CITY OF NAPOLEON - BUILDING DEPARTMENT
 255 West Riverview Avenue, Napoleon, Ohio 43545 - 419-592-4010

ADDENDUM TO Permit No. 01406 - (1)
 Owner JOHN CLYMER
 Contractor SELF
 Location 171 RAYMOND

RESIDENTIAL PLAN CORRECTION SHEET

ADDENDUM TO Permit No. 01406 - (1)
Owner JOHN CLYMER
Contractor SELF
Location 171 RAYMOND

DATE: 6/12/17
 DRAWING NO.: 330BS SHT. 9 OF 15
 SPAN: 24'-0" PITCH/DEPTH: 4/12
 DRAWN BY: MRS ENG. BY: JWR
 CHECKED BY: JFR

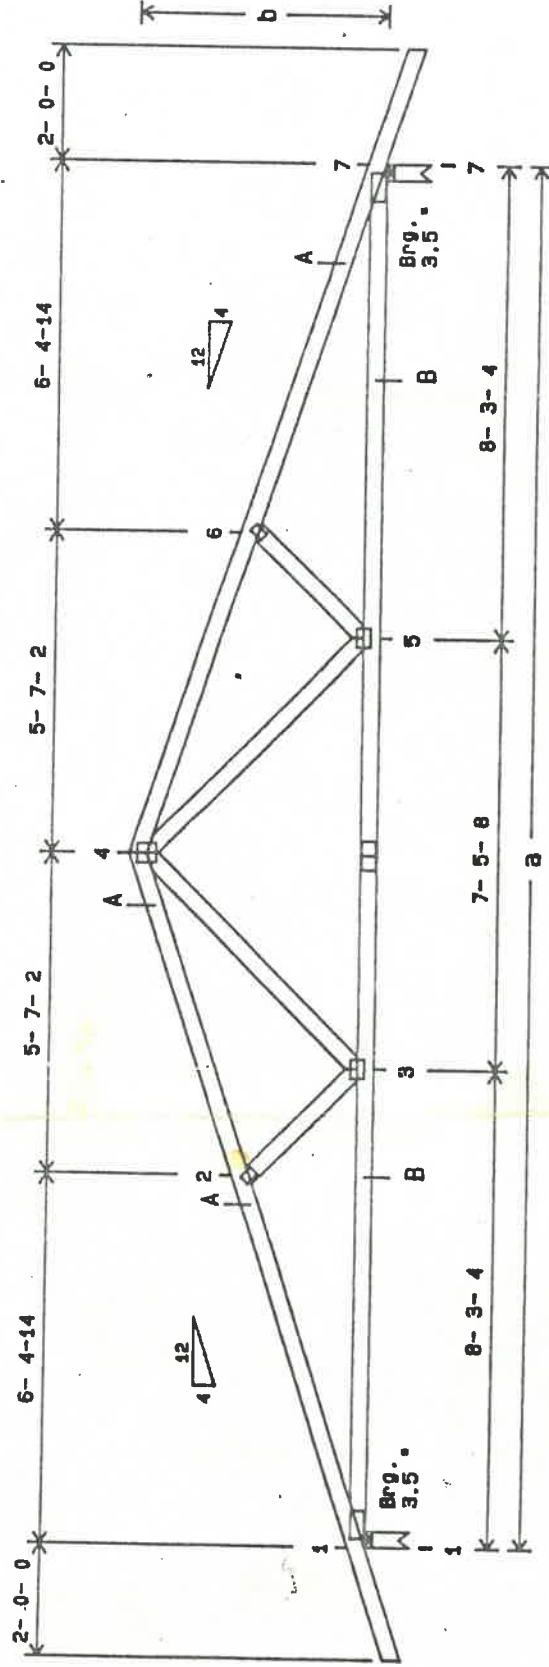
Additional Corrections. TOP OF FOUNDATION TO EXTEND 4" MIN ABOVE GRADE BOTTOM PLATE TO BE TREATED, TRUSS LOADS = 25,10,10,10 TOTAL 55. PROVIDE ENG. STAMPED DESIGN DIAGRAM.

SCALE $\frac{1}{8}'' = 6''$		
SCALE $\frac{1}{4}'' = 1'$		
SCALE $1'' = 1'$	APPROVED BY	DRAWN BY
DATE 7-8-87		L.B. ASHBAUGH
GARAGE FOUNDATION PLAN		
LOCATION	DRAWING NUMBER	
RAMOND AND THIRD ST.	4 OF 4

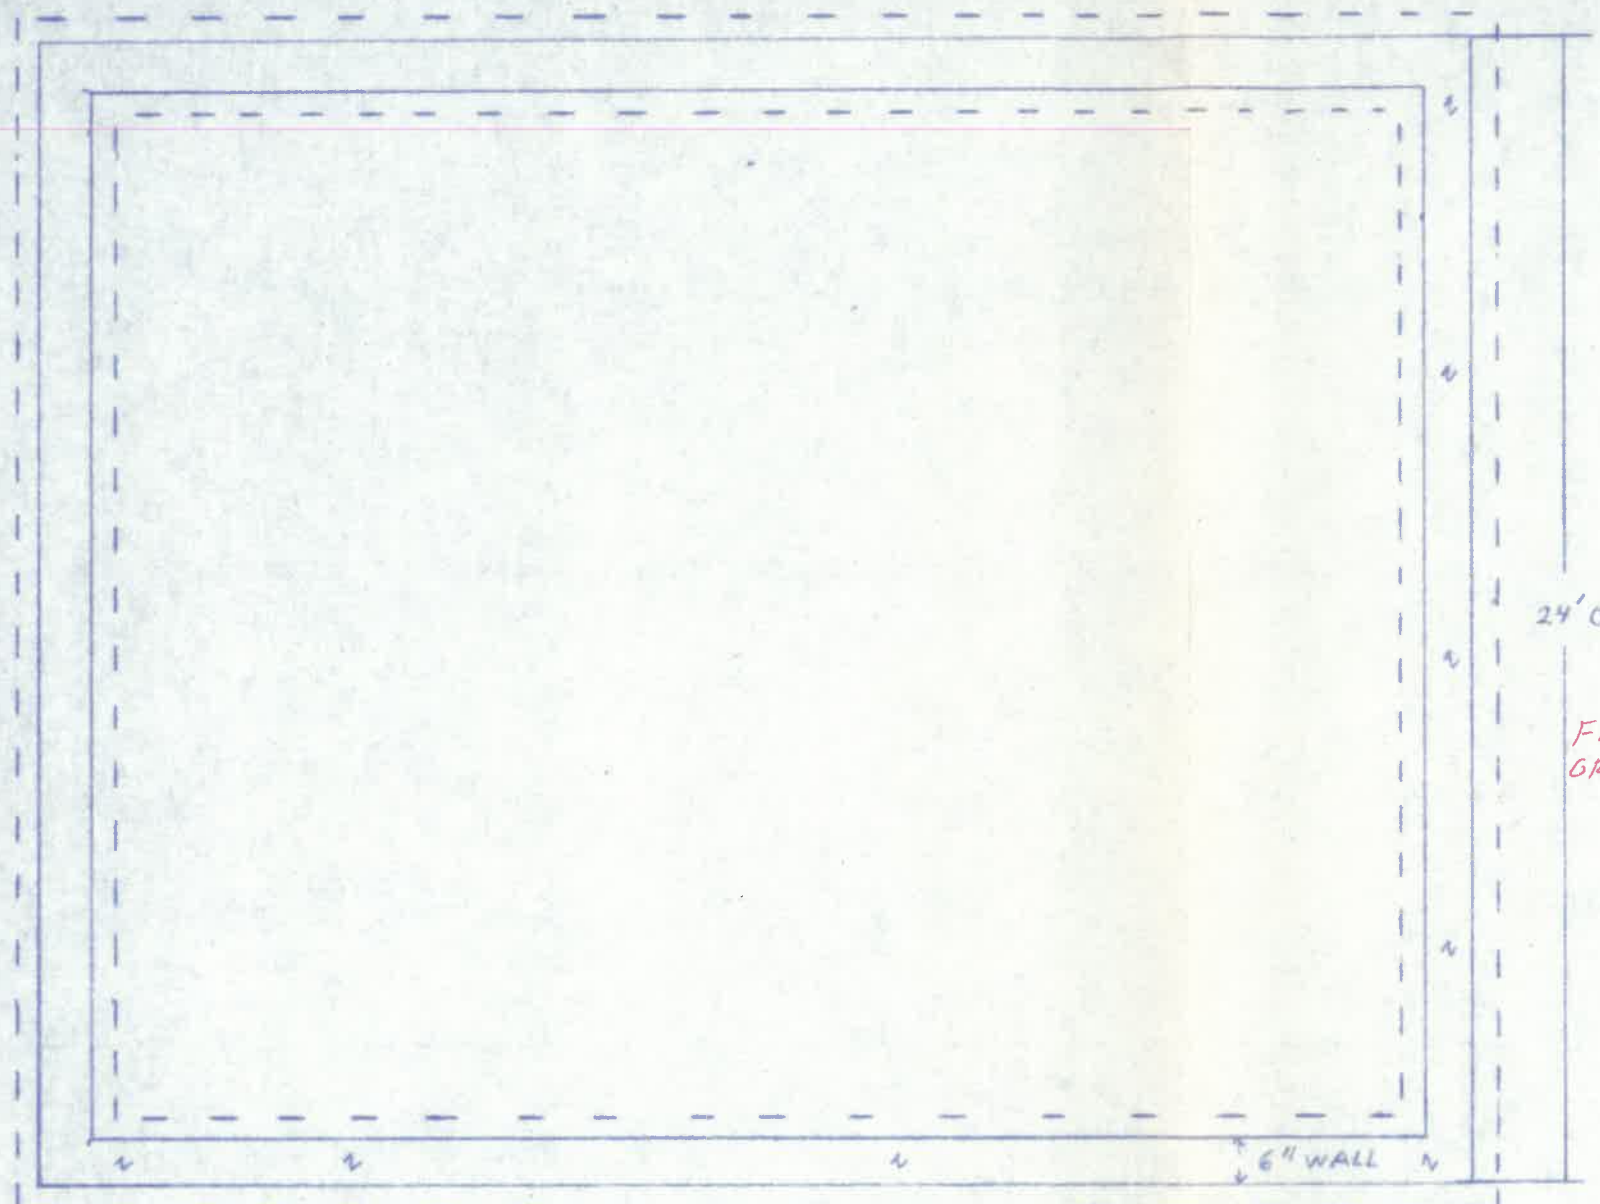
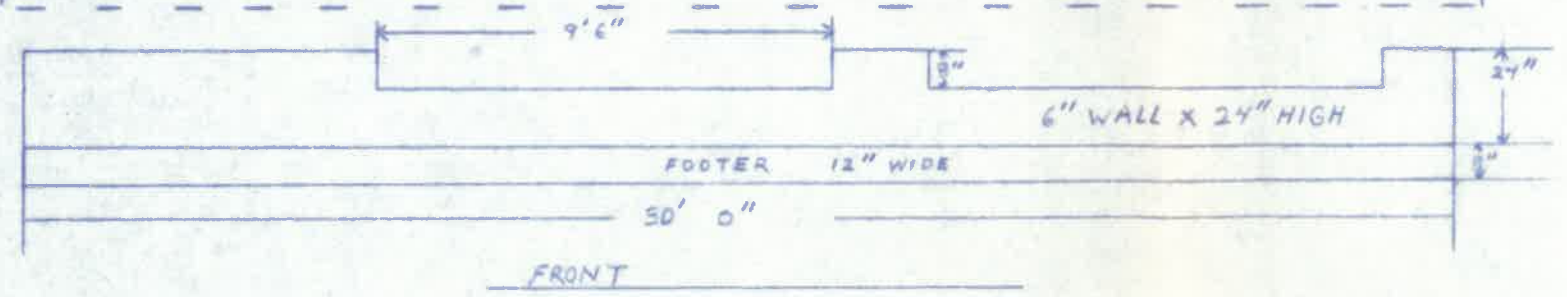
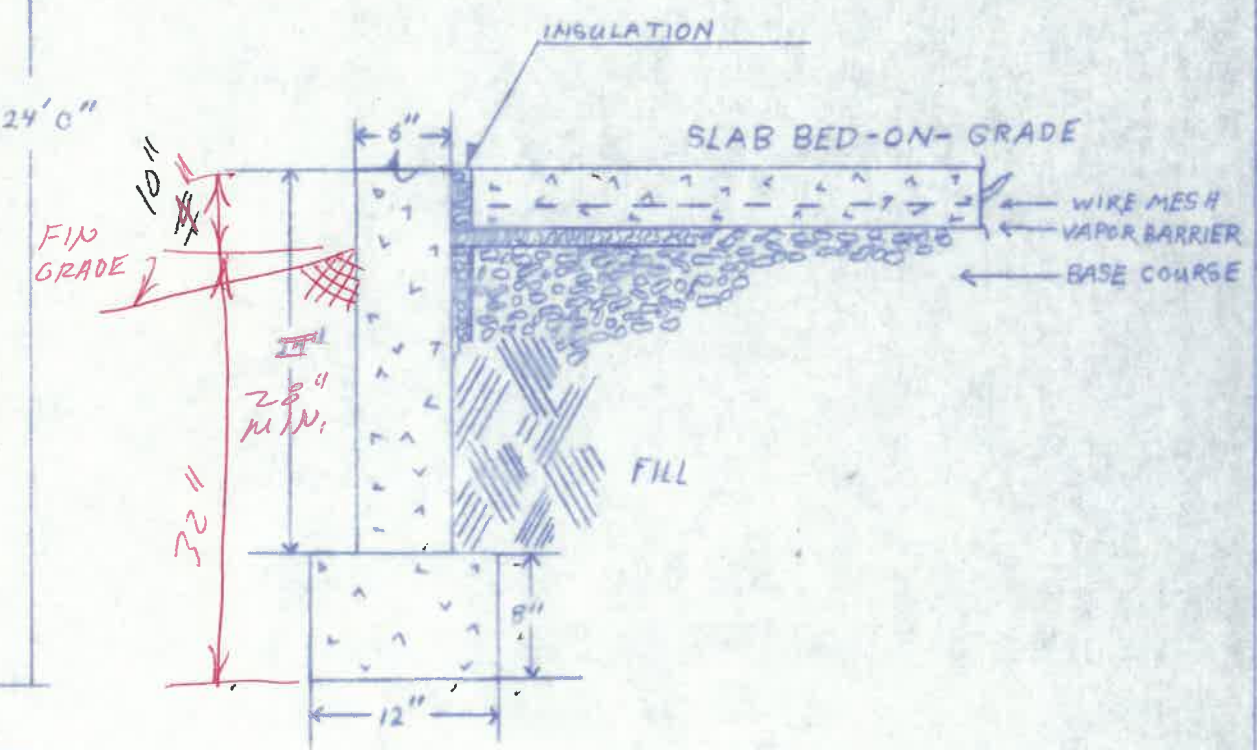
Min. size of footer _____" x _____"	Maximum number of receptacles permitted on a G. F. C. I. circuit shall be 10 for 20 A. circuits and 7 for 15A. circuits.
<input checked="" type="checkbox"/> Provide anchor bolts 1/2" @ 6' o.c. 1' from each corner. Embedded 7" in concrete and 15" in masonry.	Refrigerators, microwaves, washers, disposal, furnace and air conditioners shall be on separate circuits.
Show size of basement columns.	INSPECTIONS
FRAMING	The following indicated inspections are required. The owner or his agent shall contact the City Building Dept. at least 24 hrs prior to the time the inspection is to be made.
Show size of wood girder in _____	<input checked="" type="checkbox"/> Footers and Setbacks.
Provide design data for structural member in _____	Foundation.
Floor joists undersized in _____	Plumbing rough-in. <input checked="" type="checkbox"/>
Provide double joists under parallel bearing partitions.	Plumbing final.

Additional Corrections. TOP OF FOUNDATION TO EXTEND 4" MIN ABOVE GRADE REMOVE PLATE TO BE TREATED, TRUSS LOADS = 25,10,10,10 TOTAL 55. PROVIDE ENG. STAMPED DESIGN DIAGRAM
